Historic Landmarks and Preservation Districts Commission

Certificate of Appropriateness

Case No: 16COA1186
Classification: Staff Review

Property Address: 815 East Washington Street

Variance for side yard setback
 Required: 3 ft
 Requesting 0 ft
 SITE ADDRESS
 1 inch = 20 ft
 R-6 Residential Multi-Family District

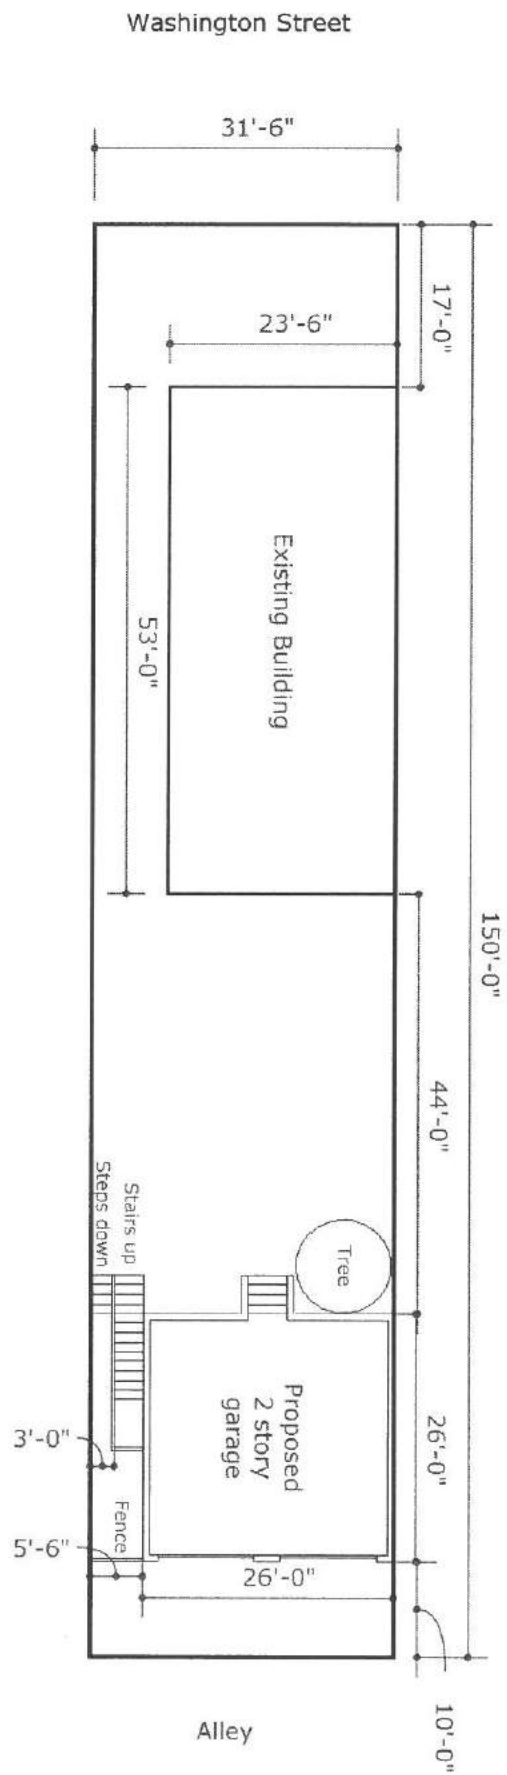
- According to your site it looks like you will be placing your garage 20' off the alley. Is this accurate? If so, do you have a reason for that? Typically, we want garages to line up with others on the alley, which appear to be 10' from the alley.
- What kind of gutters will you be using? Half round? Ogee?
- Will your privacy fence in the rear be wood?
- What material will your retaining wall be constructed of?
- The stairs that lead to the side of the garage and south doors, what material will they be?

The garage should be shown on the drawing to be 10' off the alley (let me know if I made a mistake on that) but I would like permission to place it up to 12' in case a larger vehicle I have cannot easily make that turn.

North Elevation

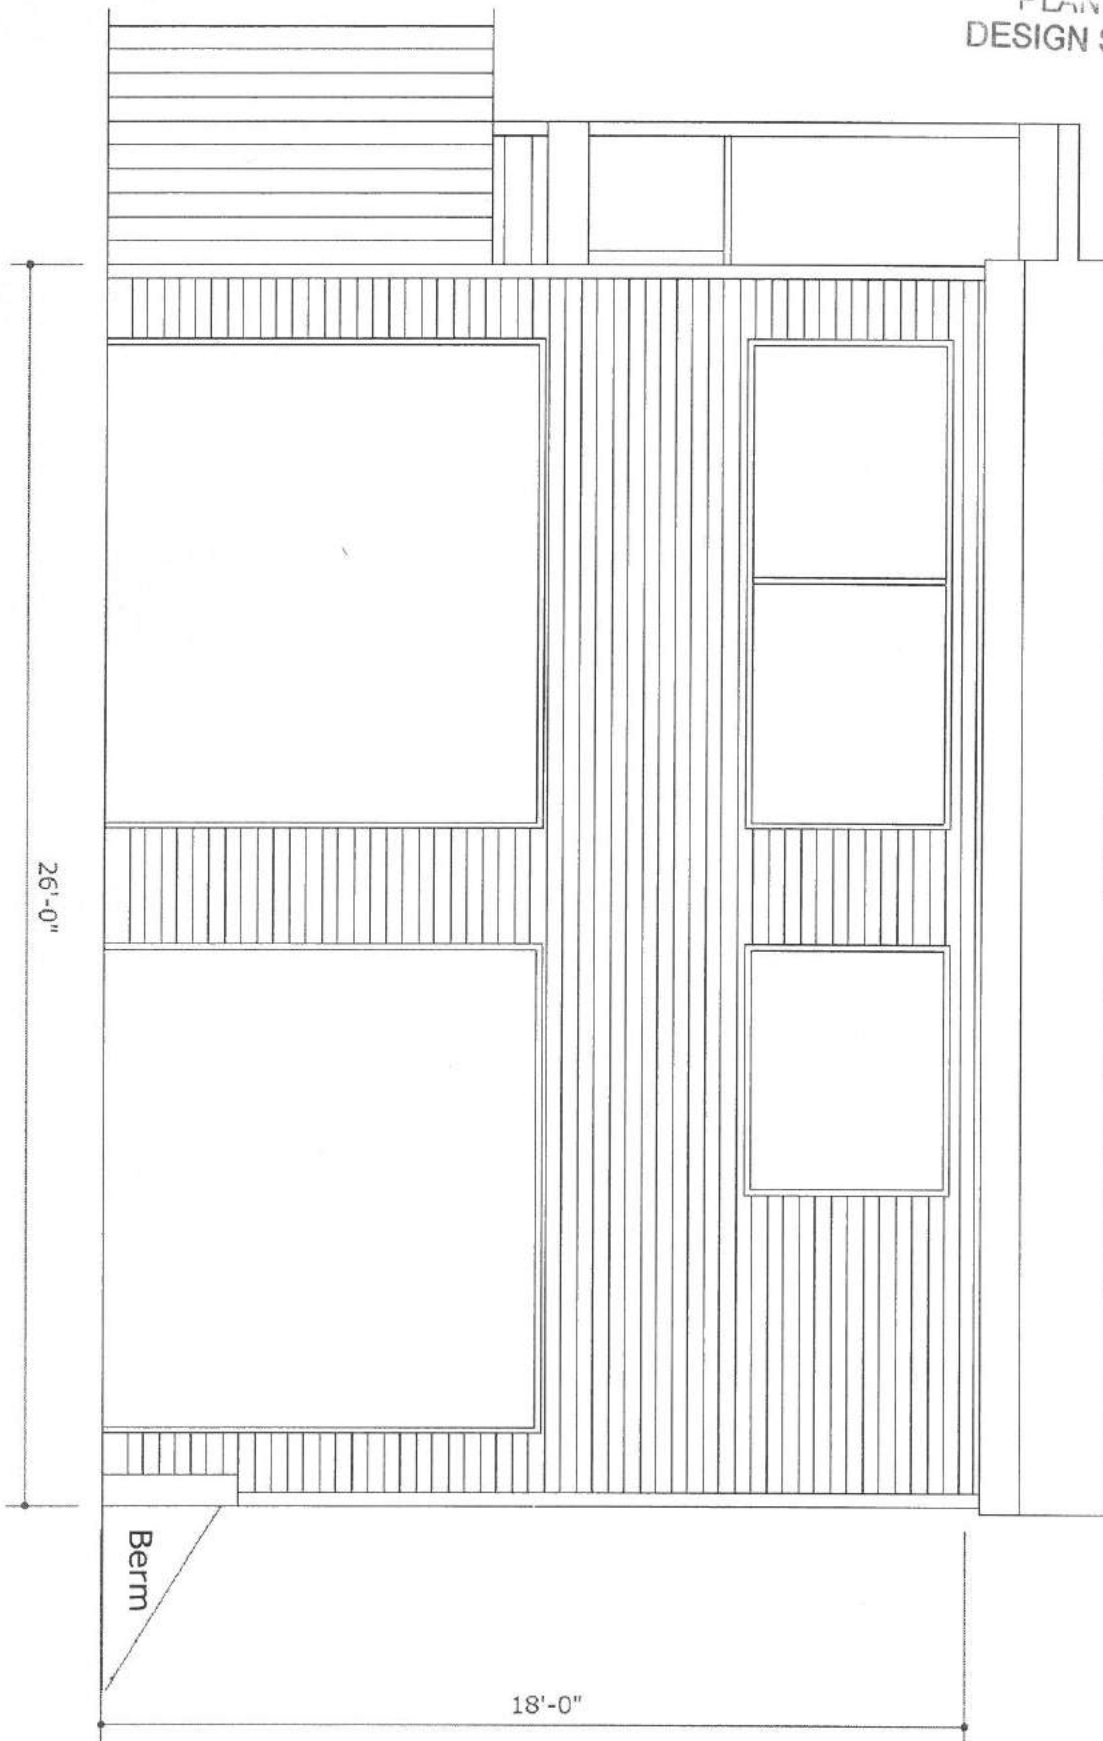
- What is your proposed roofing material? Your pitch appears to be about a 3:12, which per code has to be covered in metal or rolled roofing. If the pitch is 4:12 or higher then you can use shingles.
- Do you have a garage door style in mind? It needs to be broken up by articulated panels or stiles and rails to reduce scale.

The roof will be 3:12 or less and have metal roofing.

I have not picked out a garage door style but I will make sure it has articulated panels or stiles and rails.
